Re: NCIRT Review and USACE Approval of the Henry Fork Draft Mitigation Plan; SAW-2014-00538; DMS Project #96306

RE: NCIRT Review Portal Comments for Draft Mitigation Plan

Henry Fork Mitigation Site (DMS #96306)

SUBJECT: Henry Fork Mitigation Site - NCIRT Comments During 30-day Mitigation Plan Review

Figure 1 Vicinity Map Henry ForkMitigation Site Catawba River Basin (03050103 Expanded Service Area)

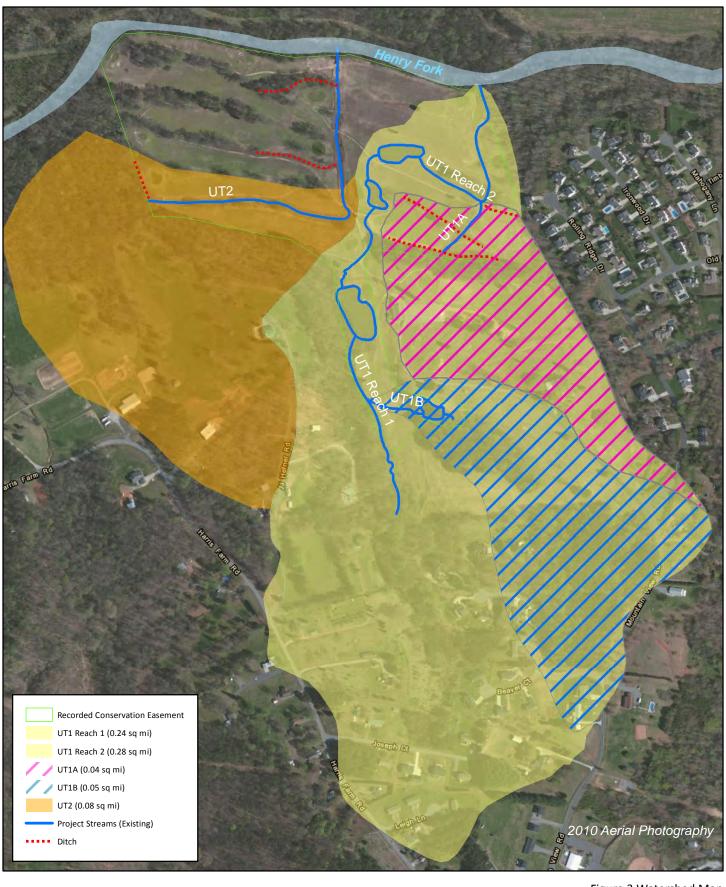
According to the information provided, this mitigation site is located in the Catawba River Basin HUC 03050102. The mitigation plan (page 1) states the site is being submitted for mitigation credit in the Catawba River Basin HUC 03050103 within the expanded service area of this HUC. Please be aware that the IRT has not approved a DMS request to expand the service area for HUC 03050103 to include CT03, CT02, and CT01. If you would like to request that the IRT consider an expanded service area for the Henry Fork mitigation site, please provide a map depicting the boundaries for the proposed service area you are requesting.

Response: The service area for HUC03050102 has been plotted on Figure 1 of the Mitigation Plan.
